CITY OF SACRAMENTO

Permit No: 9809039

**Nature of Work: REMOVE OLD ROOF & REROOF W/PIONEER TILE 4/12 PITCH SFR
(35SQS)**

Subject: Structural Investigation Report of the Roof for the Residence located at 1 Riverglade Court, Sacramento, CA 95831.

① ROOF PLAN - FREEMAN
 N.T.S.

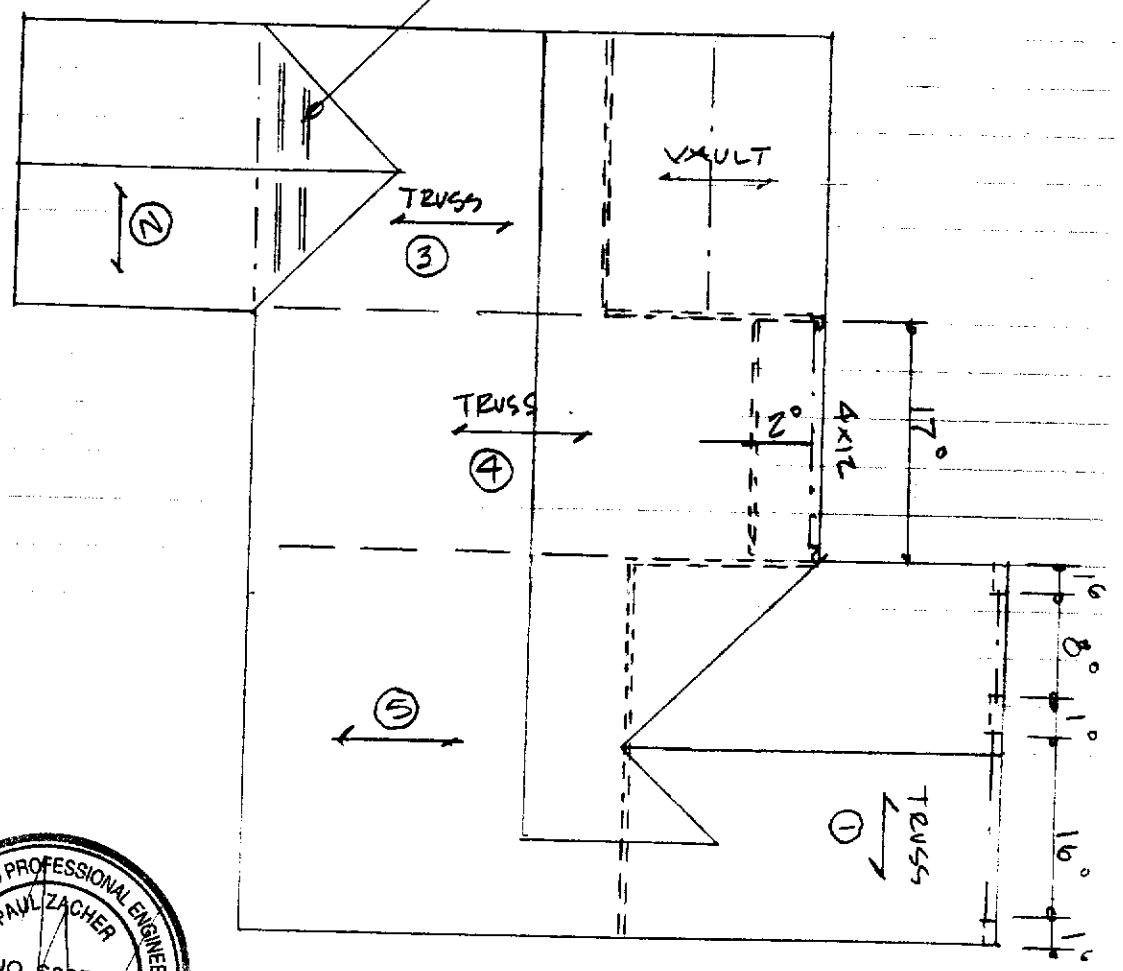
The living area has sufficient structural capacity for the applied live and dead loads. The garage lacks sufficient structural capacity for the applied live and dead loads.

1. Scab a 2x6 rafter to the existing 2x4 rafters with 16d's @ 12" on center where the span is greater than 7'-9". See detail 1.

SCAB 2x6 TO 2x4 W HOPS
 LENGTH IS 7' 7 9/16"
 (TOTAL 4)
